ENGINEERED SUBMITTAL

Lincoln HS - Teen Parent Center Bldg

Glass Skylights

Spec No 086300 - Metal Framed Skylights

1 RIDGE DETAIL
6"=1'-0" ARCH. REF. = 51/A516

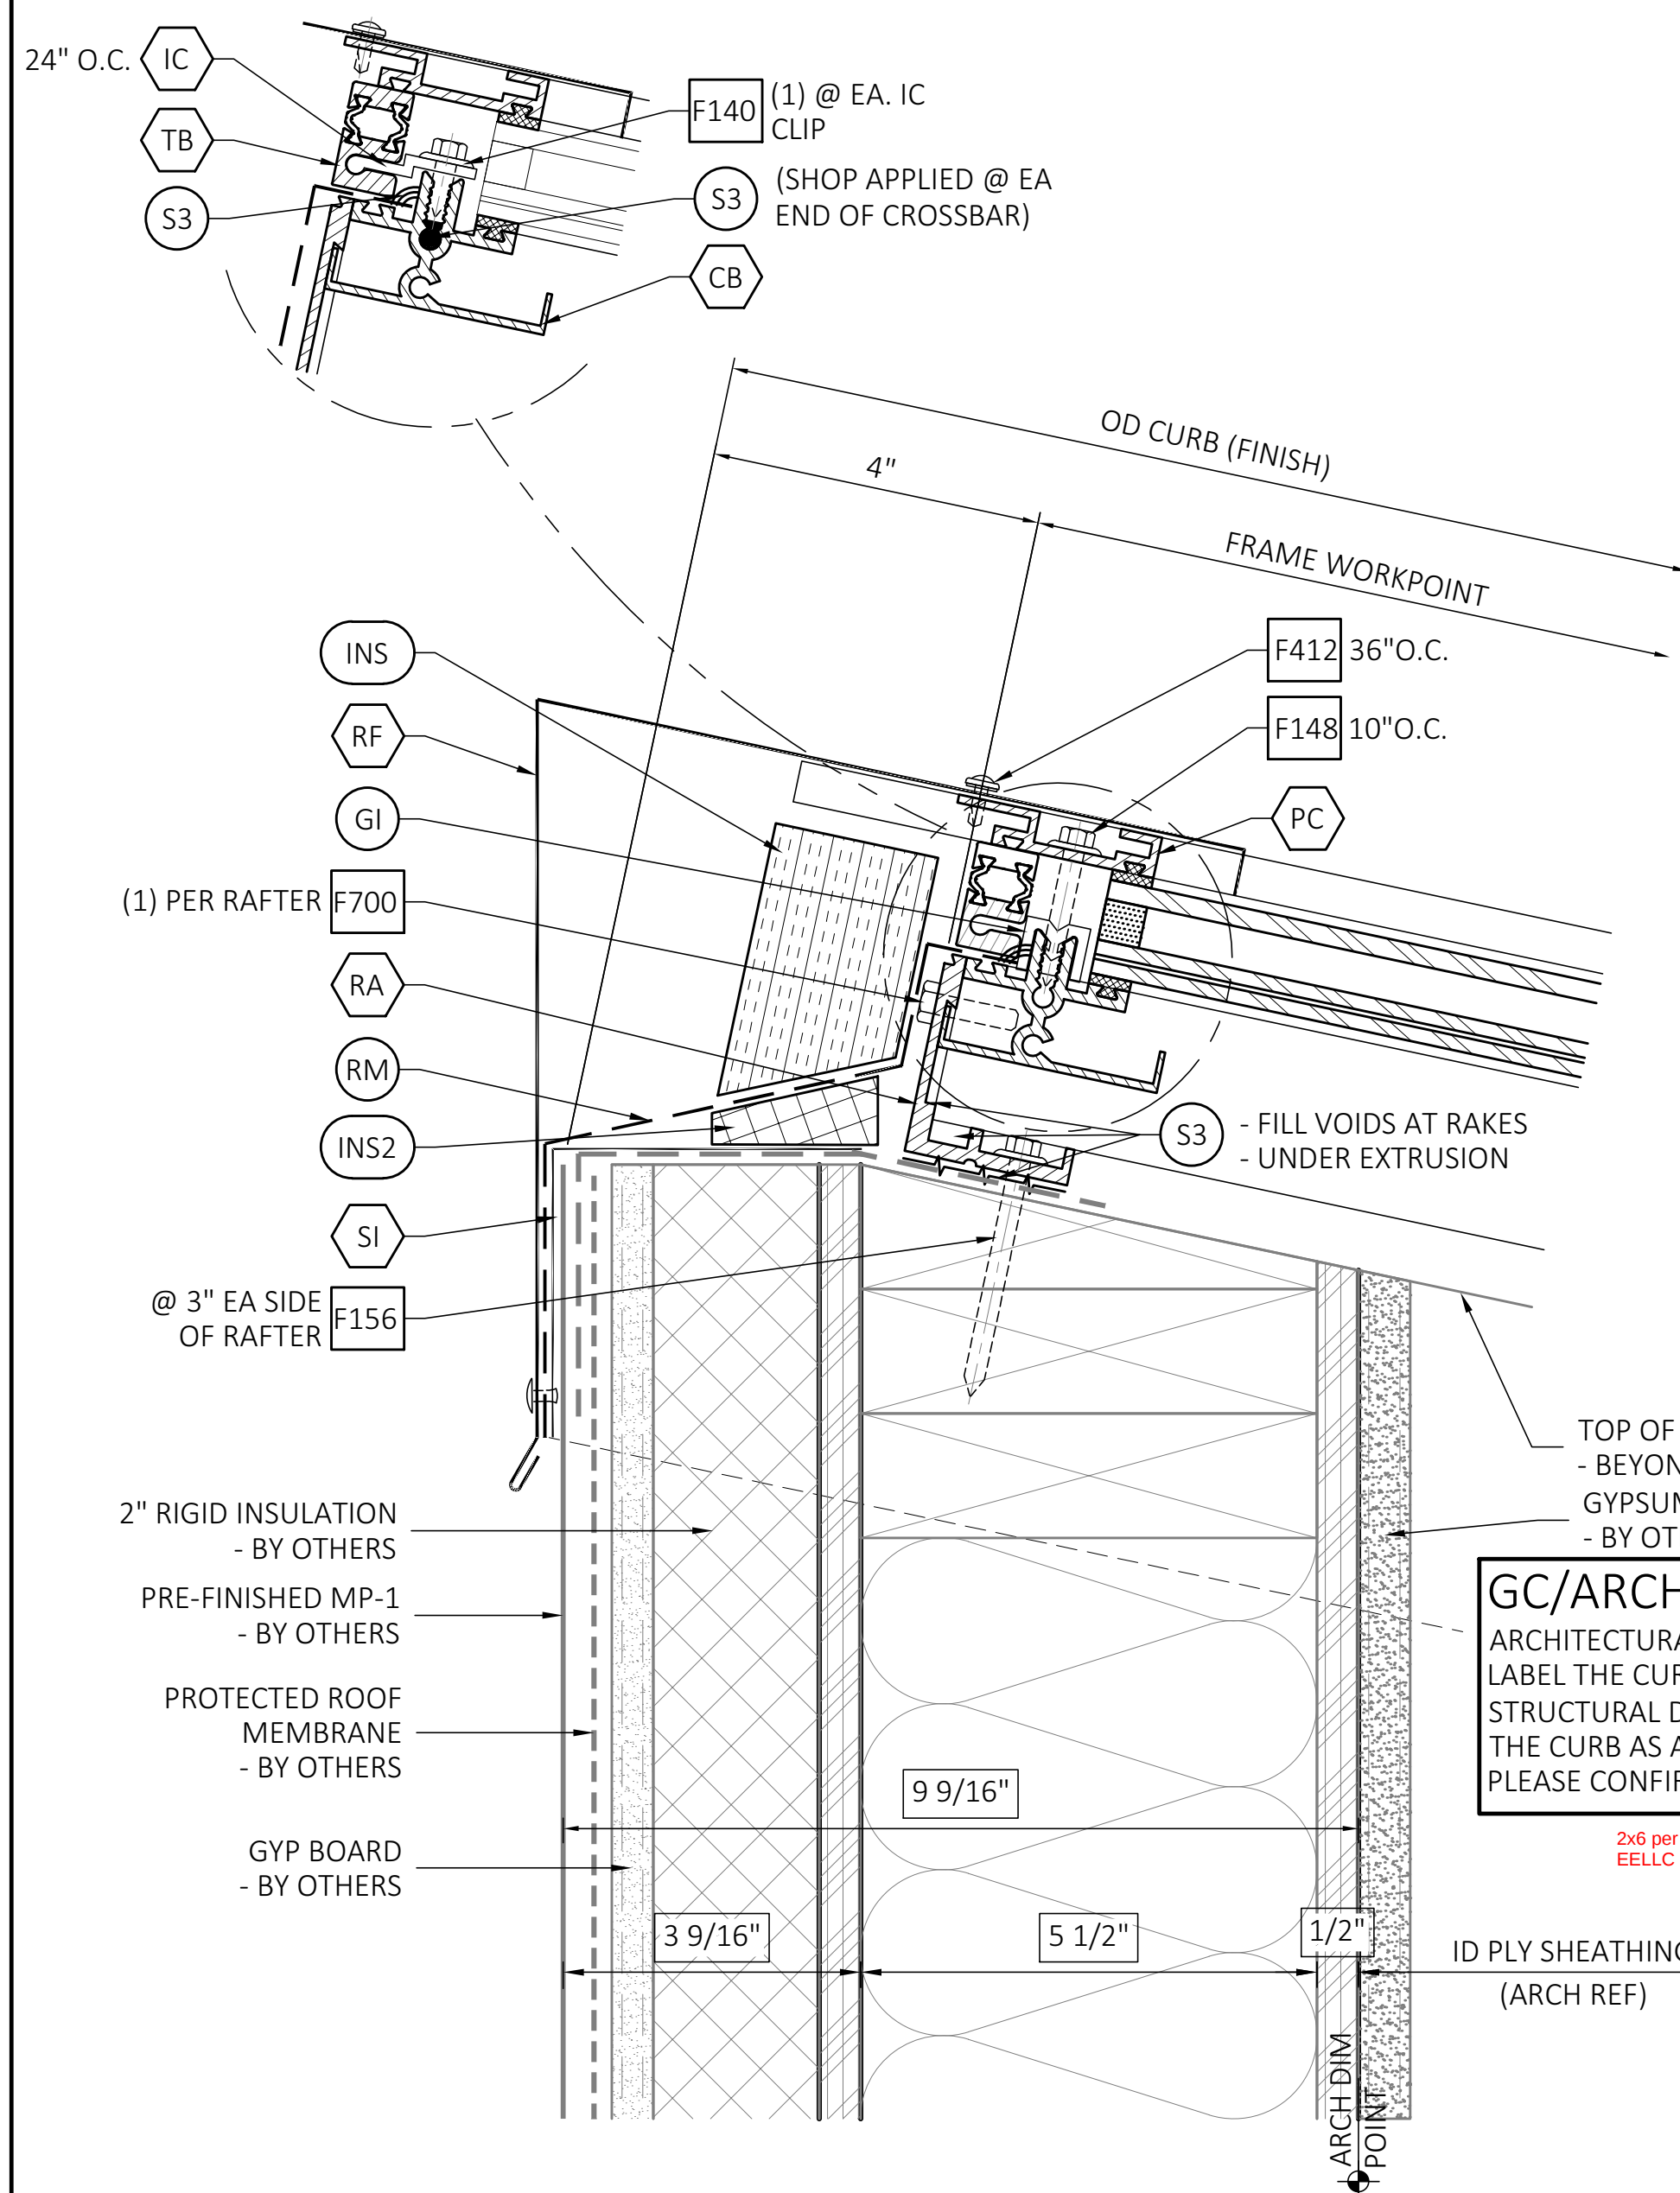
GC/ARCHITECT NOTE!
DEAMOR REQUIRES CURBS TO BE CONSTRUCTED IN SLOPE WITH COPLANAR RAKES FOR ALL SKYLIGHTS, SIMILAR TO THOSE SHOWN IN THE CDs FOR THE CUSTOM FRAMED SKYLIGHT.

2 EAVE DETAIL
6"=1'-0" ARCH. REF. = 41/A516

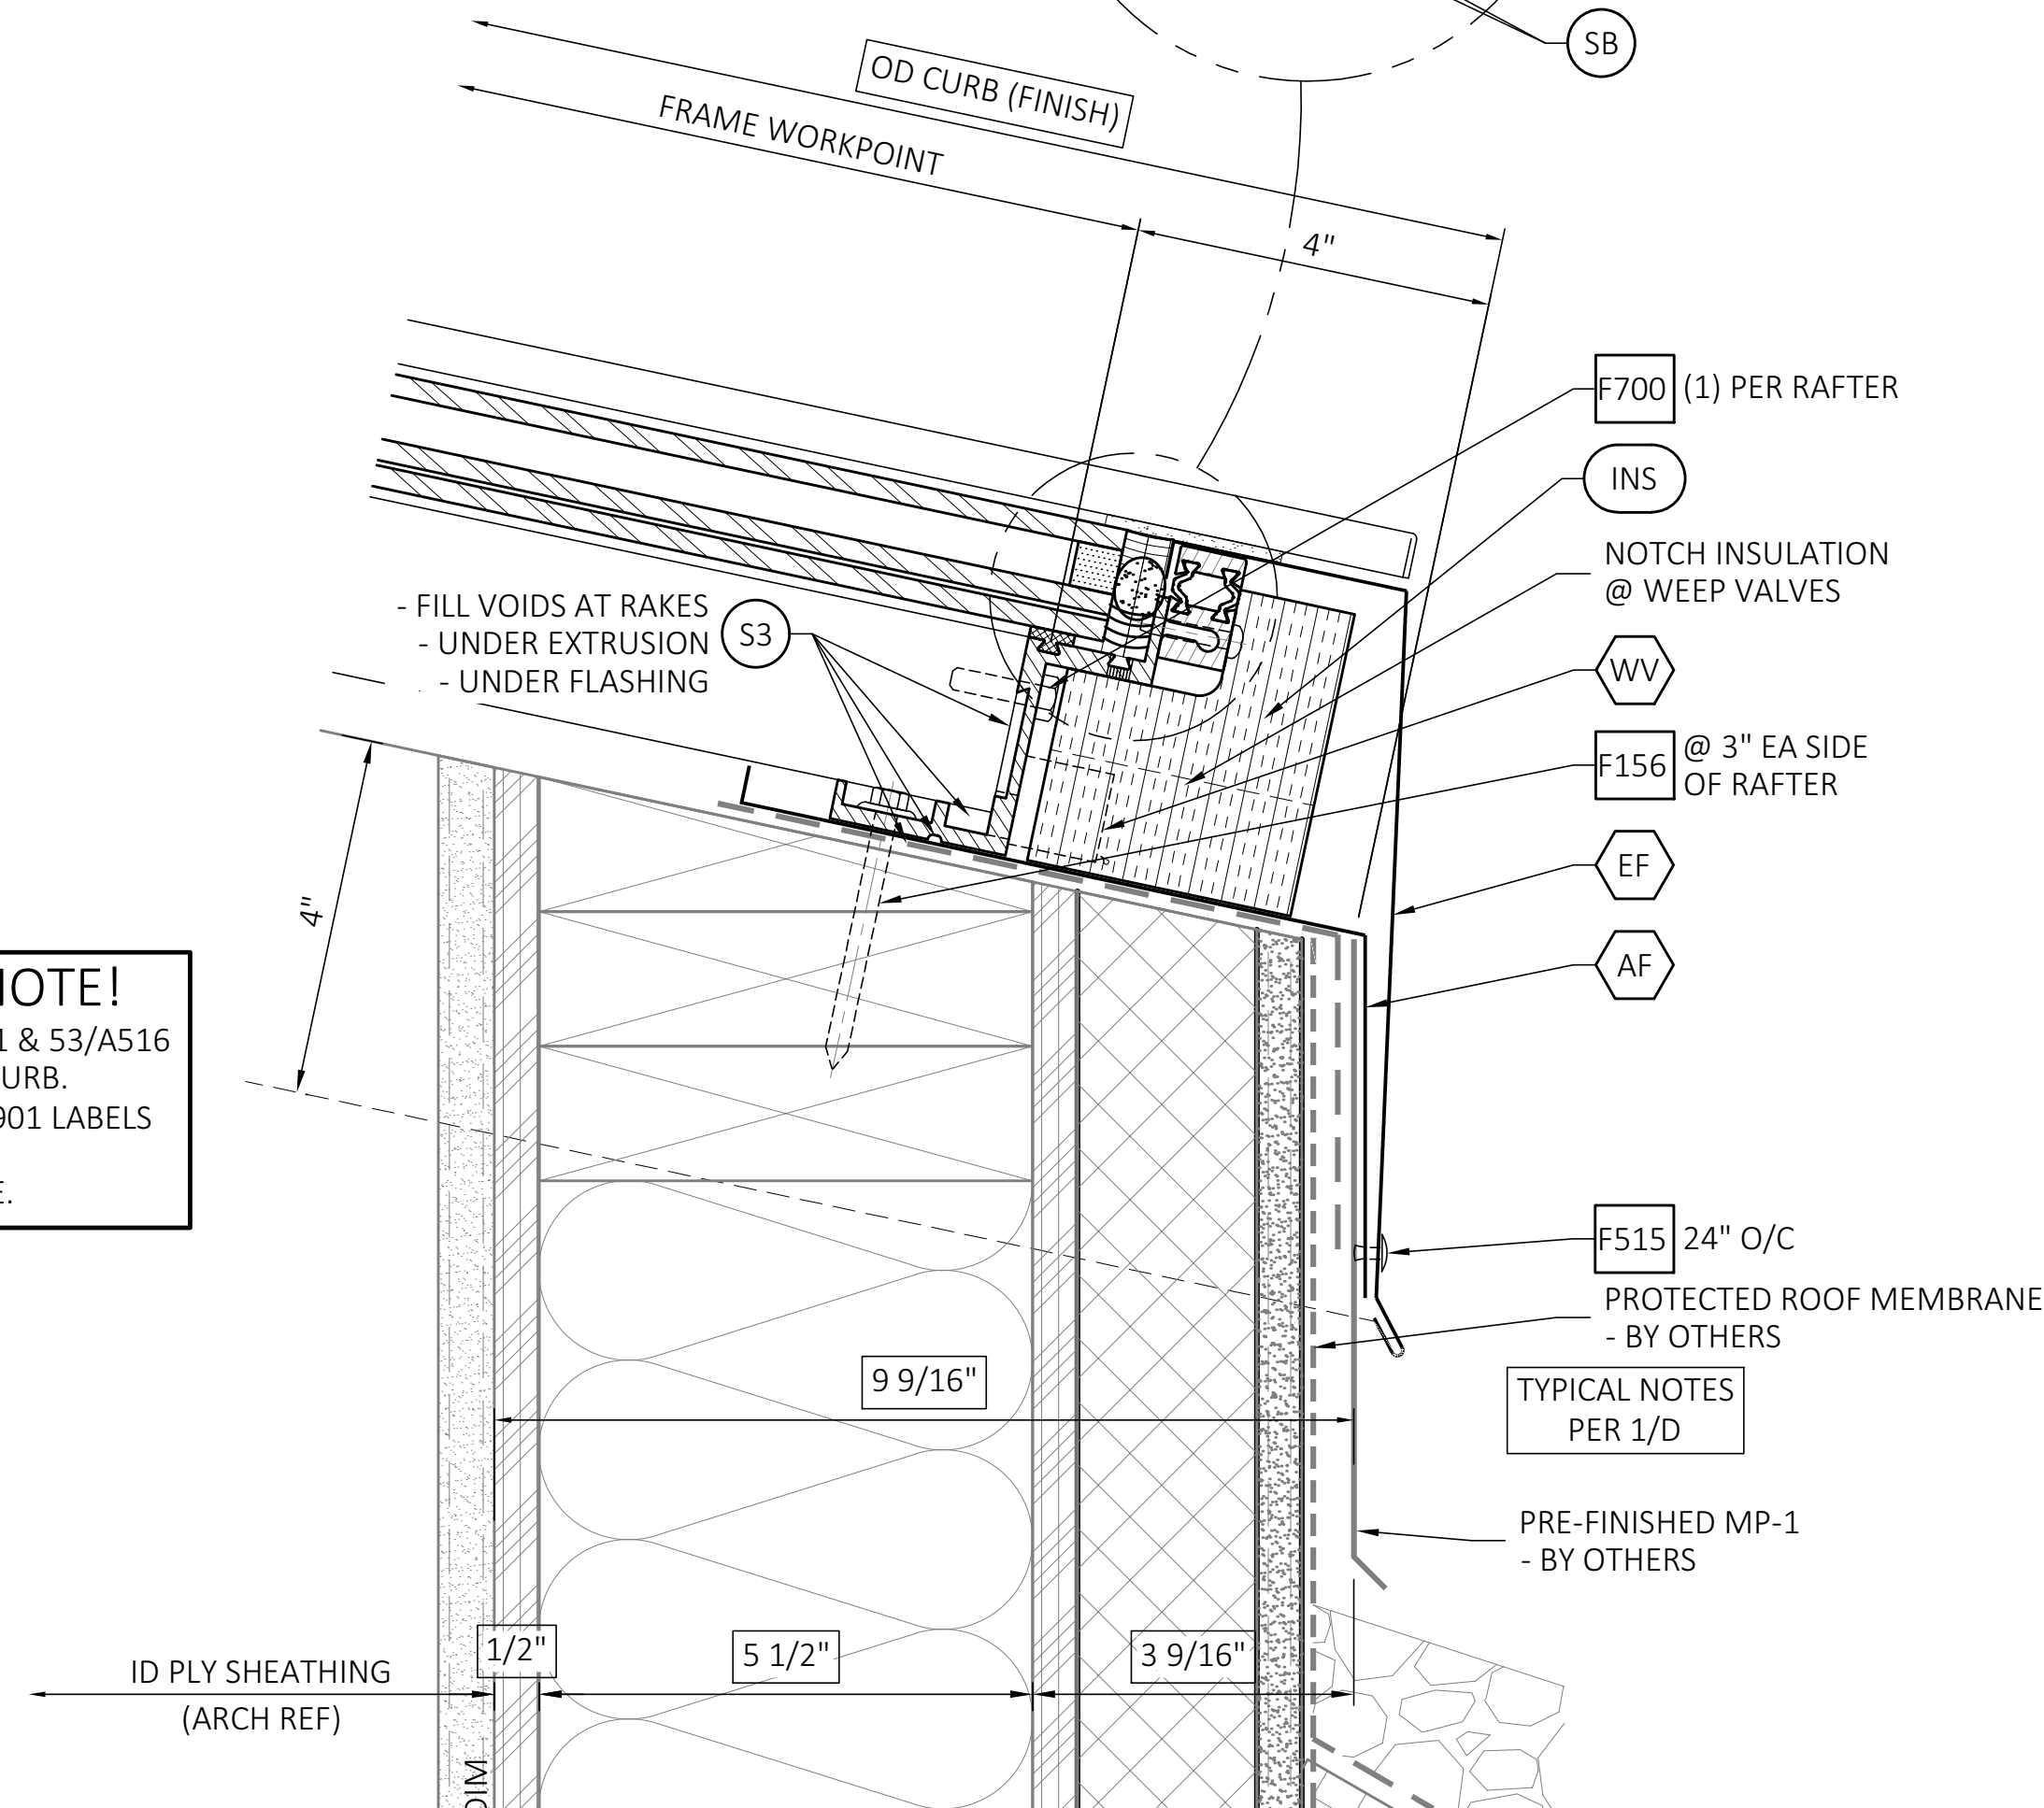
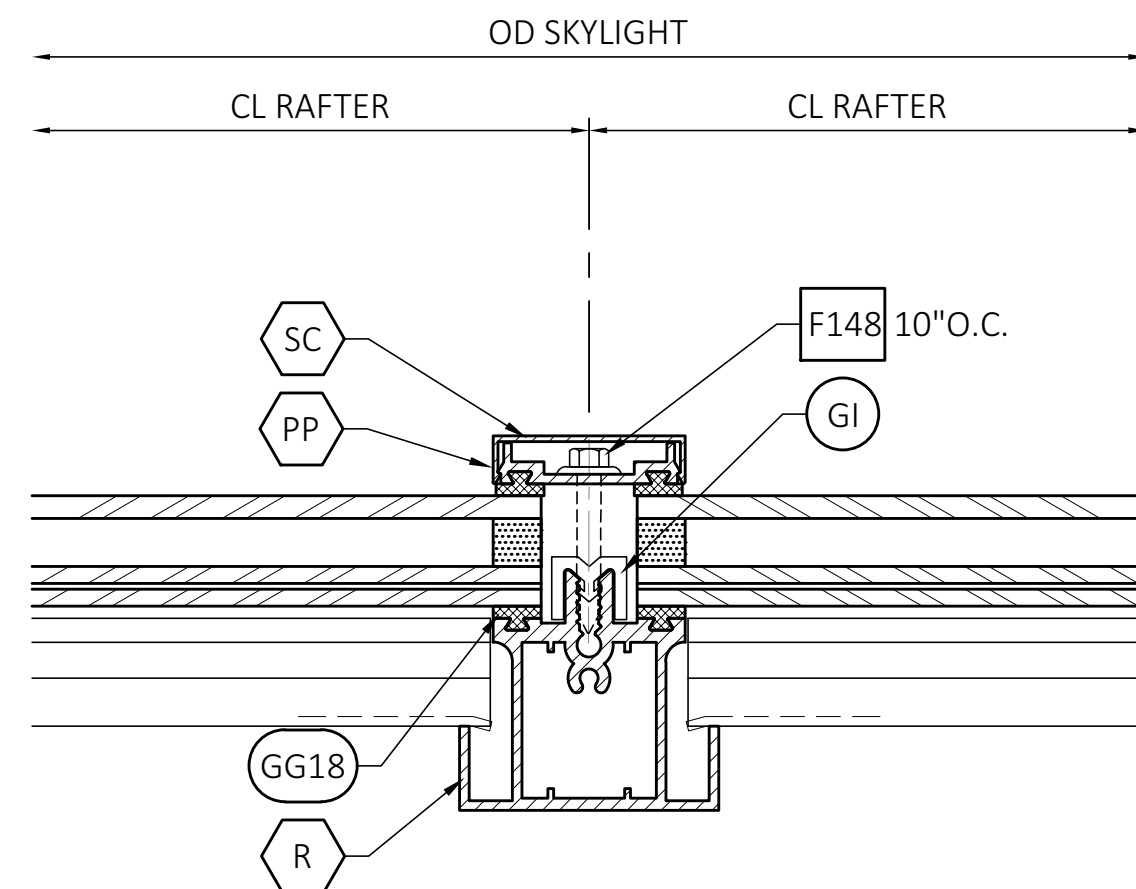
GC/ARCHITECT NOTE!
ARCHITECTURAL DETAILS 41 & 53/A516 LABEL THE CURB AS A 2x4 CURB. STRUCTURAL DETAILS 10/S901 LABELS THE CURB AS A 2x6 CURB. PLEASE CONFIRM STUD SIZE.
